Planning and Economic Development
Ed Anzek, AICP, Director

From: James Breuckman, AICP
To: City Council
Date: 2/2/2012
Re: Zoning Amendments

Attached to this memo is the Ordinance Draft of a raft of Zoning Amendments recommended for approval by the Planning Commission at their January meeting.

Following is an illustration of a standard gas station layout with 75 foot front setback:

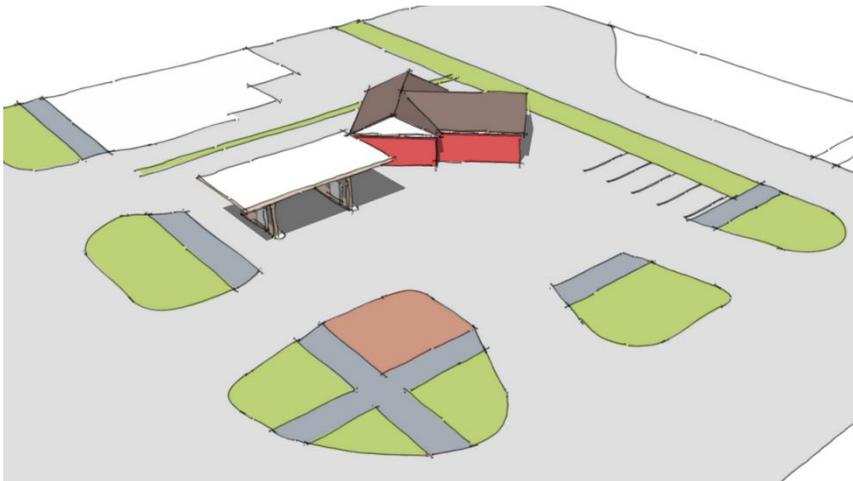
Front Building/Rear Canopy Gas Stations

This new provision would provide an alternate form of development for gas stations that can help to alleviate design issues at existing gas stations. The provisions allow for a drastically reduced building setback requirement that allows for the building to move closer to the street while moving the canopies back behind the building, effectively concealing or reducing the visual impact of the pump areas.

This is an option that may be chosen by the property owner, and will likely only be used at corner lots where pumps will still be visible from the street. This option does bring some benefits, however:

- It improves circulation patterns by moving driveways away from an intersection.
- It increases the quality of the streetscape by moving a building closer to the street, providing a better definition of space along the street and also improving the pedestrian environment.

Here is a potential layout at the same site that uses the front building/rear canopy layout:
